Document Identifier: 51 - 9004805 - 001

Title: FCS RSG - AFAS Verification - RAI Responses

This document provides responses to NRC RAIs on the AFAS setpoint verification analysis (attachment 4 of the following reference).

**Figure 1 Nodalization Diagram of Affected Steam Generator
Showing Boiler Section Noding**

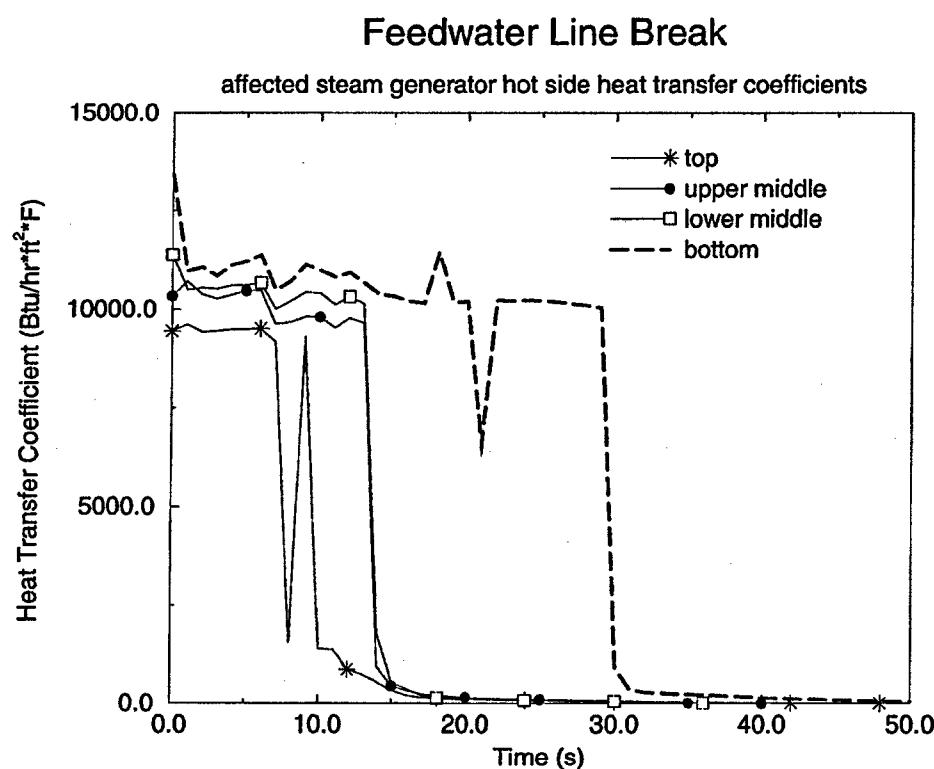
Discuss the SG heat transfer model in S-RELAP5 for events that experience SG dryout.

Provide the values of SG dryout heat transfer coefficients used in the analysis of non-LOCA transients, in particular, the loss of main feedwater (LMFW) and feedwater line break (FLB) events.

The FLB scenario is presented first. The boiler section consists of four vertically stacked control volumes with two sets of heat structures representing the 'up' and 'down' portions of the steam generator tubes. Figure 1 shows a nodalization diagram for the affected steam generator. In that figure, component 524 represents the boiler section with node 524-1 representing the bottom node, 524-2 representing the lower middle node, 524-3 representing the upper middle node, and 524-4 representing the top node of the boiler section. The initial void fraction profile in the affected steam generator boiler section varies from 0.37 at the bottom to 0.81 at the top. In the first 10 seconds after the blowdown is initiated, the void fraction in the top boiler section transitions to above 0.97, and the heat transfer coefficient transitions from approximately 10,000 BTU/hr·ft²·°F to approximately 1,500 BTU/hr·ft²·°F. The void fraction transitions to all vapor by 40 seconds and the ultimate total heat transfer coefficient becomes approximately zero. The lower sections show similar characteristics at later times. Figure 2 shows the total heat transfer coefficients for the hot side, bottom through top, nodes from time 0.0 to 50 seconds. For comparison purposes, Figure 3 shows heat transfer coefficients from the unaffected steam generator. The quantities shown are from the structures representing the hot side. The nodal heat transfer coefficients remain relatively constant until their respective control volumes dry-out. Note that the heat transfer coefficient from the bottom node retains a finite value greater than zero throughout the transient. This is the effect of auxiliary feedwater on the nodal heat transfer coefficient.

Figure 5 Normalized Total Heat Transfer Versus Normalized Total Steam Generator Mass in Affected Steam Generator

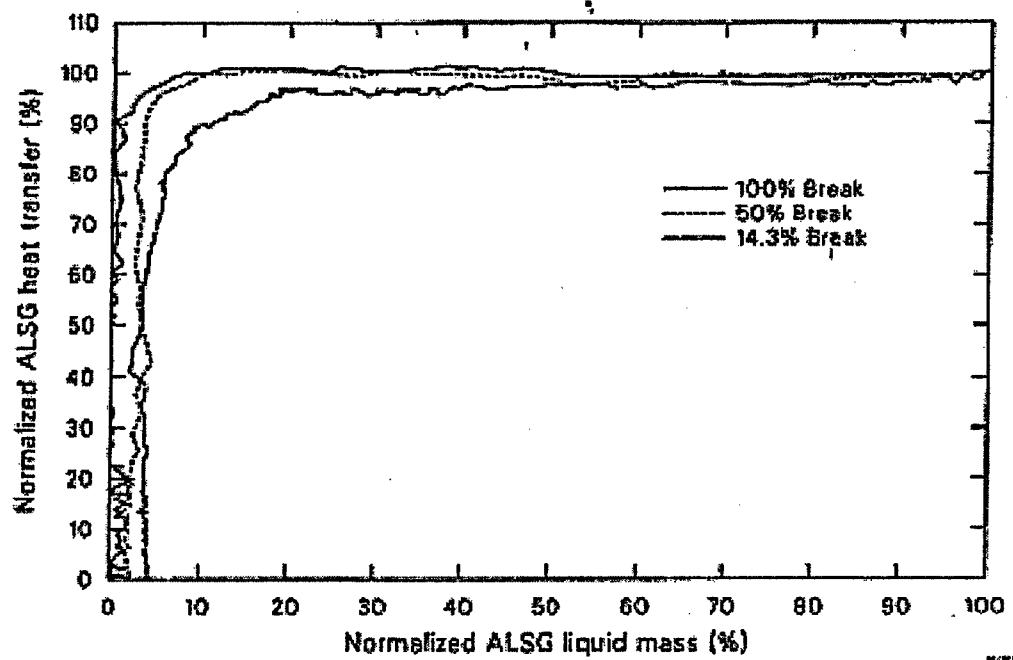
The Semiscale test data for FLB (as discussed in Section 4.3.3.2 of NUREG/CR-4945, dated July 1987) show that SG heat transfer capacity remains unchanged until the SG liquid inventory is nearly deleted. This is followed by a rapid reduction to zero percent heat transfer with little further reduction in the SG water inventory. In light of these test data, you are requested to verify that the heat transfer model used in the LMFW and FLB events (that experience SG dryout) is conservative as compared to the Semiscale test data.

The next figure, Figure 5, is presented to demonstrate that the S-RELAP5 calculations of feedwater line break are conservative with respect to Semiscale feedwater line break Tests S-FS-6, S-FS-11, and S-FS-7 (NUREG-4945). Figure 5 shows the normalized total primary to secondary heat transfer versus the normalized total steam generator mass for the affected steam generator from the previously mentioned tests and from selected S-RELAP5 calculations. Note that the data in this figure was digitized from the plot on page 70 of NUREG-4945, thus there is some uncertainty concerning the absolute values of the data, but the trends are approximated adequately. Figure 6 shows a reproduction of the NUREG-4945 figure for verification that the digitized data is acceptable.

In Figure 5, the data shows more than 90% heat transfer until the inventory is reduced to below 20%, after which the heat transfer is reduced ultimately to zero. The smallest break, 14.3%, decreases to zero from 20% to 5% inventory while the larger breaks show the heat transfer decreasing to zero over the span of 10% to 0% inventory. In contrast, the calculated heat transfer starts decreasing between 40% and 50% inventory. The early decrease is due to the top boiler node drying out for the break sizes shown. As the inventory further decreases, the next two boiler section nodes dry-out and the heat transfer again decreases. Finally, at approximately 10% inventory the bottom node becomes virtually empty and the heat transfer is approximately zero. The results shown are conservative with respect to the Semiscale data.

Although a 14.3% break calculation was not performed, it would be expected to show similar behavior as the other calculations. That is, dry-out in the top boiler node will immediately decrease the heat transfer. As the lower sections experience dry-out, abrupt drops in heat transfer will occur with decreasing inventory. The Semiscale data and the calculations show the same trend relative to break size. Thus, all break size calculations are expected to show less heat transfer than the Semiscale data. Therefore, S-RELAP5 calculates conservative heat transfer with respect to Semiscale.
